PCN-20220309 TE0715-04 to TE0715-05 Hardware Revision Change

Company	Trenz Electronic GmbH
PCN Number	PCN-20220309
Title	TE0715-04 to TE0715-05 Hardware Revision Change
Subject	Hardware Revision Change
Issue Date	2022-03-14

Affected Product	Replacement
TE0715-04-*	TE0715-05-*

#26 Change schematic documentation.

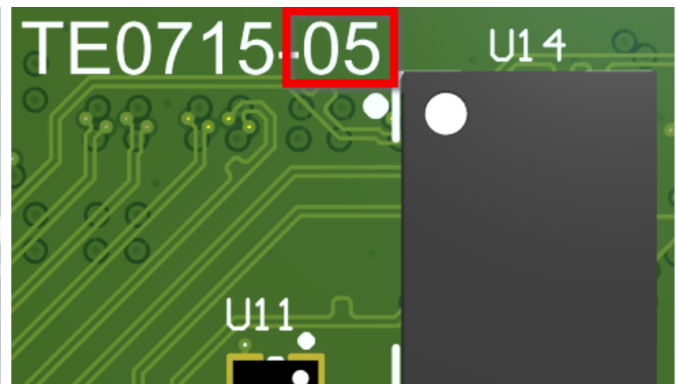
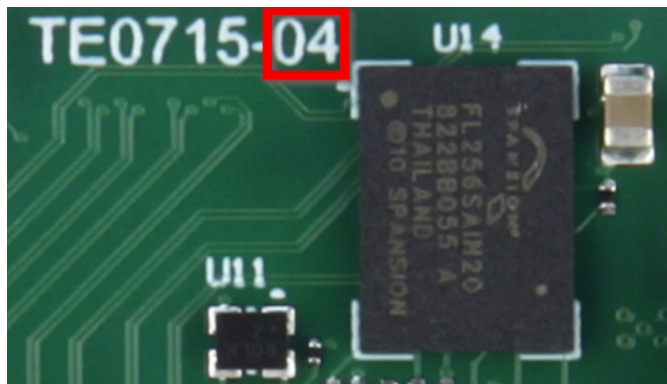
Type: DOC Change

Reason: Documentation optimization.

Impact: None. B2B information, legal notices, revision history, system overview, and power diagram are inserted or changed. Schematic page number changes.
